Submission on RVUNL's Petition for True-Up of FY 2024-25 and ARR & Tariff for FY 2026-27

Rajasthan Rajya Vidyut Utpadan Nigam Limited (the Petitioner) has filed a Petition seeking True-Up of its Aggregate Revenue Requirement for FY 2024-25 and Aggregate Revenue Requirement and Tariff for FY 2026-27 before the Rajasthan Electricity Regulatory Commission (the Commission), in accordance with the provisions of the applicable Tariff Regulations, 2025. The Petition has been made available on the website of the Commission for inviting objections and suggestions from stakeholders.

This submission from Centre for Energy, Environment and People, Jaipur is in response to the Commission's invitation for comments. We request the Commission to take note of our written submission.

Figure 3: Plant-wise deviation in availability

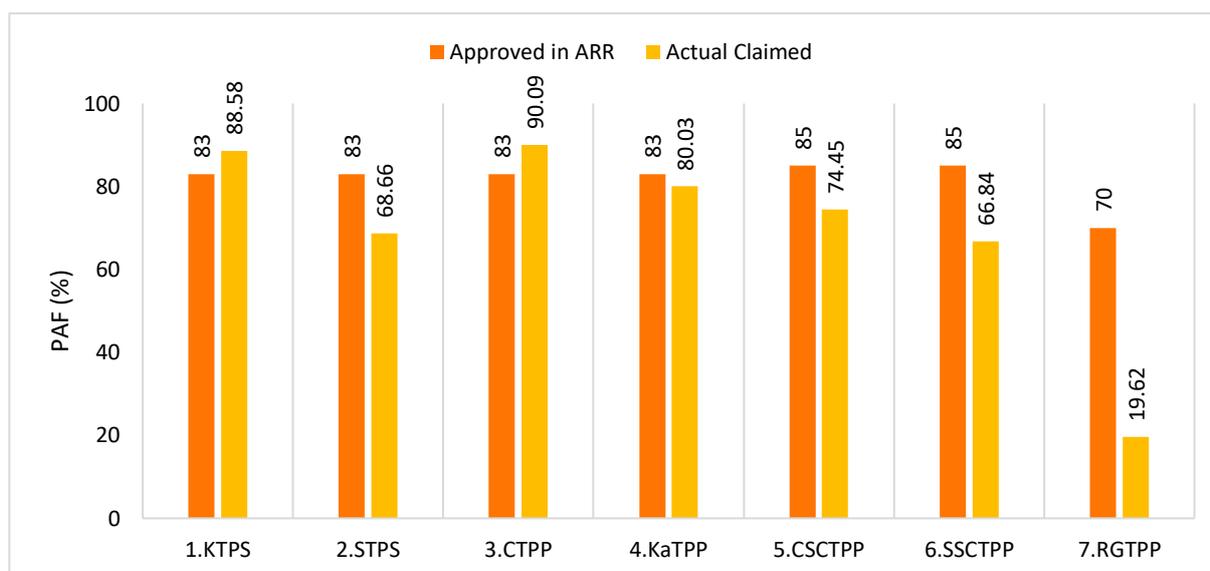
As per the data submitted by the Petitioner for FY25, plant availability across a majority of generating stations continues to remain materially below the levels approved by the Commission. Except for KTPS and CTPP, all other stations have failed to achieve their respective approved availability targets (*see Figure 3*). STPS, CSCTPP and SSCTPP have recorded availability levels lower than approved norms by 17.28 per cent, 12.41 per cent and 21.36 per cent respectively. KaTPP has also underperformed, with availability lower than the approved level by 3.58 per cent.

The persistence of such deviations, especially at stations with relatively newer assets such as CSCTPP and SSCTPP, points to continuing operational and maintenance deficiencies rather than isolated or uncontrollable events. Despite these recurring shortfalls, the Petitioner continues to project normative availability while seeking recovery of full fixed charges, without demonstrating any commensurate improvement in operational performance or placing on record a credible corrective roadmap.

It is submitted that sustained underachievement of approved availability directly undermines system reliability and compels the distribution licensees to rely on short-term market

purchases to meet demand, thereby exposing consumers to higher and volatile power procurement costs.

In view of the above, it is respectfully submitted that the Commission may direct the Petitioner to furnish plant-wise explanations for failure to meet approved availability targets during FY25, along with time-bound, station-specific measures proposed to address these deficiencies. Further, consistent with the applicable tariff framework, recovery of fixed charges ought to be restricted to a pro-rata basis in proportion to actual availability achieved, and full fixed charges should not be allowed for stations that have failed to meet the approved availability norms during the year.

Figure 4: Increase in SHR and SCC of the all coal-based plants of the Petitioner

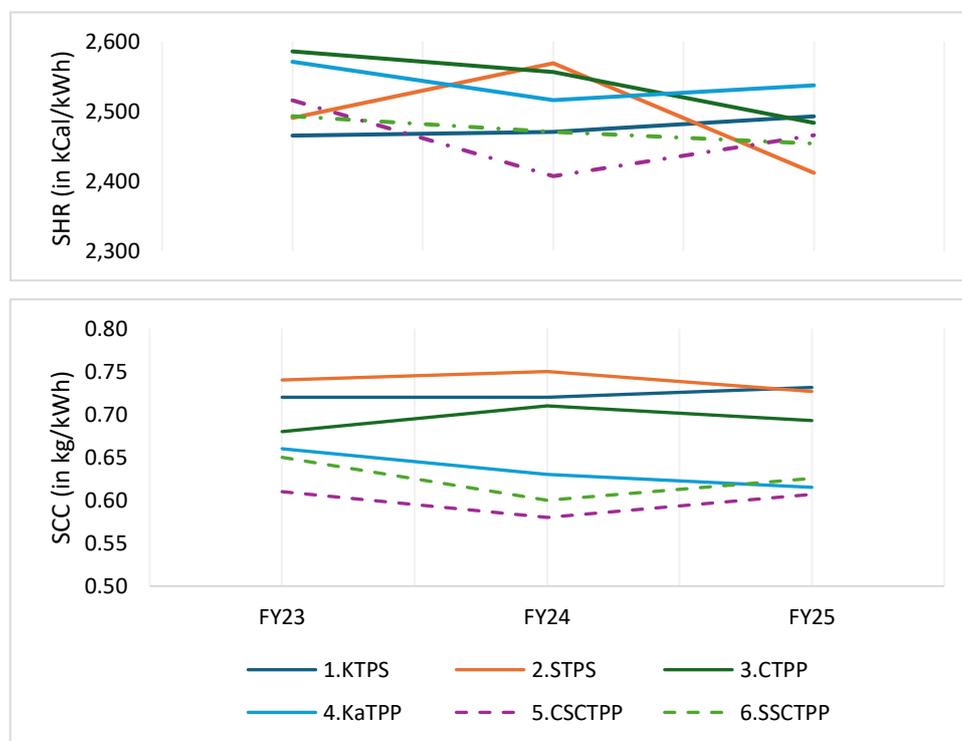
The Commission, while approving tariff for FY25, specified normative Station Heat Rate (SHR) and Specific Coal Consumption (SCC) for the Petitioner. The Petitioner’s submissions reveal significant deviation from these parameters at multiple stations. Elevated SHR and SCC indicate that, for every unit of electricity generated, these stations consumed more coal than permitted under the approved norms, thereby increasing the cost of generation.

Notably, the SHR and SCC of the supercritical stations of the Petitioner have reported a significant increase this year from their approved value. They have also shown an increase when compared to their actual numbers of previous year as well (see Figure 4).

This increase in SHR and SCC has led to notable increase in cost of generation. For example, if the Petitioner’s plants had consumed coal as per the approved SHR and SCC to generate the actual quantum of electricity they would have saved nearly Rs. 700 Cr. on cost of generation and equal reduction in aggregate energy charges (The plant-wise impact of such inefficiency is summarised below at Table 3)

The above analysis establishes that the Petitioner’s newer and supercritical stations (KaTPP, SSCTPP, and CSCTPP) imposed an avoidable burden exceeding Rs. 700 crore on consumers during FY25. While aggregate fuel expenditure at these stations appears lower than approved due to reduced generation, the cost incurred per unit of electricity actually generated was materially higher than the normative benchmark. In the case of CTPP, inefficiency-driven excess coal consumption coincided with a sharp increase in coal prices, exposing consumers simultaneously to higher fuel costs and declining operational efficiency.

However, the Petitioner’s submissions do not provide any station-specific explanation for the persistent elevation of SHR and SCC at SSCTPP, CSCTPP, KaTPP, or CTPP. Generic references to lower PLF, auxiliary consumption behaviour, or system constraints do not explain why coal consumption per unit of generation exceeded approved norms. No technical audit, root-cause analysis, or corrective action plan has been placed on record. The Petitioner has failed to attribute the observed deviations in SHR and SCC to controllable or uncontrollable factors, despite such attribution being mandatory under the Tariff Regulations, 2025 and determinative of tariff treatment, particularly where deviations in these explicitly controllable performance parameters have direct implications for consumer tariff.

In the absence of any credible explanation or evidence of remedial action, the excess coal cost arising from deviation in SHR and SCC remains unsubstantiated and cannot be presumed to be prudently incurred. The burden of such inefficiency ought not to be passed through to consumers merely because aggregate fuel expenditure appears lower due to under-generation. The Commission may therefore direct the Petitioner to furnish plant-wise technical justification for deviation from approved SCC, along with details of corrective measures undertaken, and subject the resultant excess coal cost to strict prudence scrutiny before allowing any pass-through to consumers.

Figure 7: Actual year-wise PAF of Petitioner’s coal-based thermal power plants

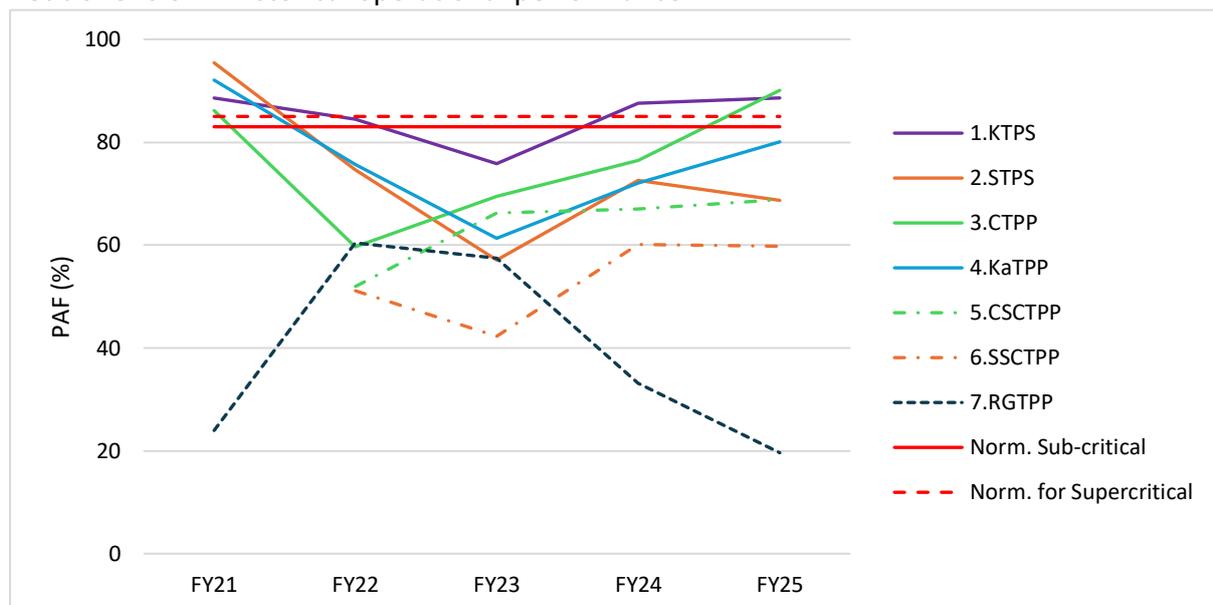
The Petitioner has proposed normative Plant Availability Factors (PAF) for FY27 in line with the RERC Tariff Regulations, 2025. It has set targets of 83 per cent for all generating stations, except SSCTPP and CSCTPP at 85 per cent, and RGTPP at 70 per cent. While these targets are consistent with the regulatory framework, their achievability must be assessed against the Petitioner’s own historical operational performance.

A review of actual PAF over the preceding financial years indicates that majority of generating stations have failed to meet the applicable normative benchmarks (see Figure 8). The continued underperformance of Petitioner’s plants with availability substantially below the normative level, remains particularly concerning.

In the absence of any demonstrable and structural shift in operational reliability, maintenance practices, the proposal to meet normative targets appears optimistic and unsupported by evidence. Merely reiterating regulatory norms, without addressing underlying causes of historical underachievement, does not provide a sound basis for tariff determination. Acceptance of such targets risks inflating fixed cost recovery assumptions, which may not materialise in practice and subsequently lead to tariff distortions or true-up adjustments.

In this context, it is respectfully submitted that the Commission may direct the Petitioner to justify the proposed normative PAF targets for FY27 with reference to concrete, station-wise evidence of operational improvements achieved or firmly underway. The Petitioner may further be directed to place on record a detailed, plant-specific action plan, including timelines and measurable milestones, demonstrating how the proposed PAF levels will be realistically achieved during FY27. In the absence of such substantiation, the Commission may consider approving availability targets aligned with recent actual performance, rather than purely normative assumptions, for the purpose of tariff determination.

Figure 8: Actual year-wise PLF of Petitioner’s coal-based thermal power plants

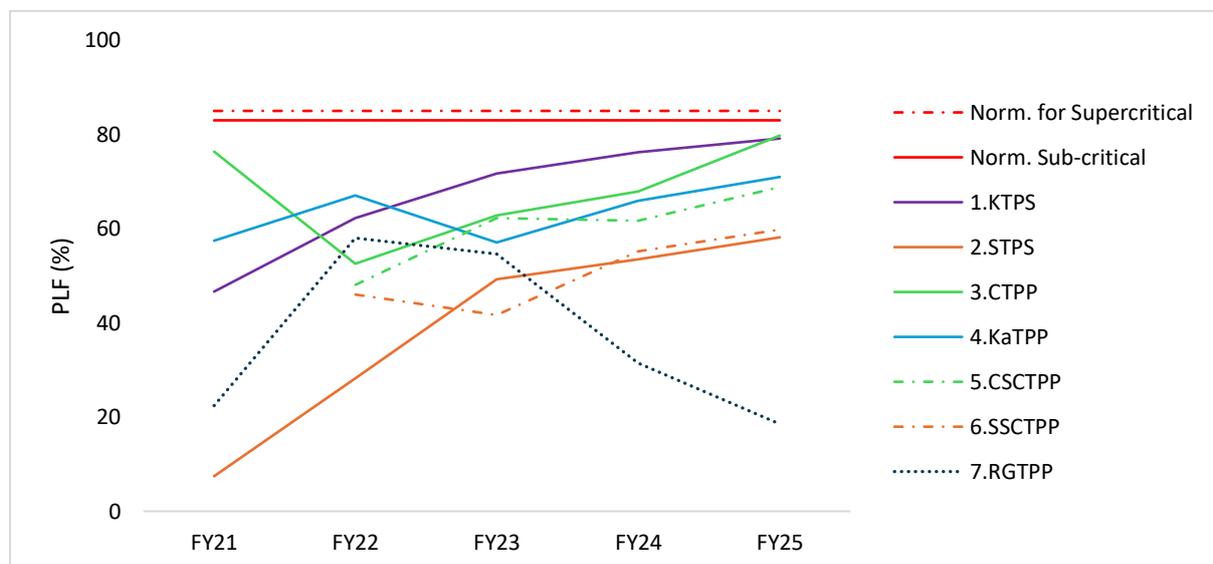
In its Petition seeking approval of ARR and tariff for FY27, the Petitioner has proposed normative PLF targets of 83 per cent for all generating stations, except SSCTPP and CSCTPP at 85 per cent and RGTPP at 70 per cent, in line with the RERC Tariff Regulations, 2025.

However, an examination of actual PLF performance over the last five financial years (see Figure 9) indicates that none of the generating stations have achieved their respective normative PLF levels up to FY24. This sustained underperformance calls into question the

realism and achievability of the proposed PLF targets, particularly in the absence of any demonstrated improvement in operational reliability or identifiable systemic interventions to address plant-specific constraints.

In these circumstances, it is submitted that the Petitioner should be directed to seek approval of PLF levels aligned with its actual performance. Such an approach would also not adversely affect the power planning of the Discoms, who may otherwise rely on the Petitioner's projections while determining procurement from alternative sources.
